September 9, 2022

Re: SP 22-01 – Hampton Pointe Dental Office (3<sup>rd</sup> Submittal Review Cycle)

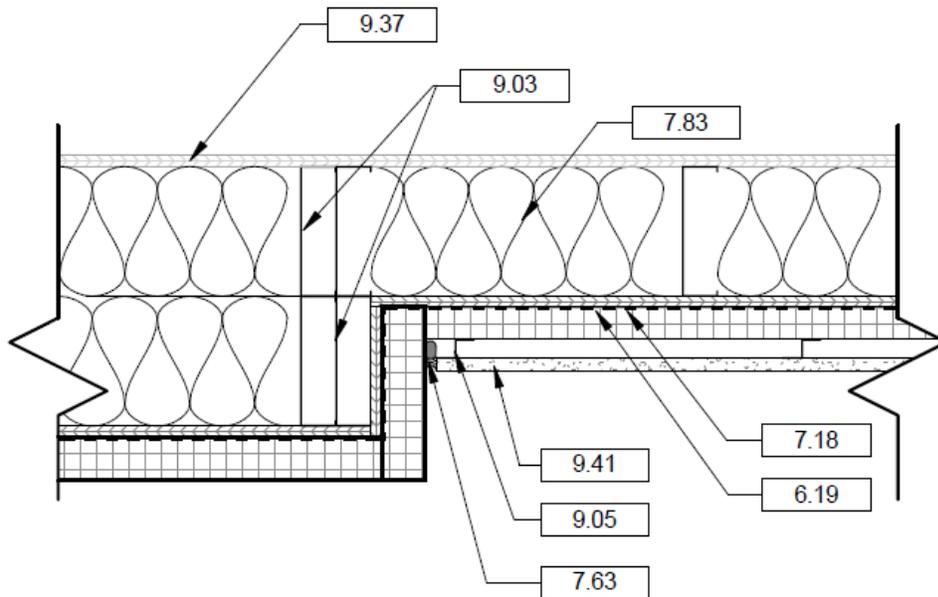
- 15. Comment:** Label this fixture (Sheet A4.1)

***Response: Fixture has been labeled.***
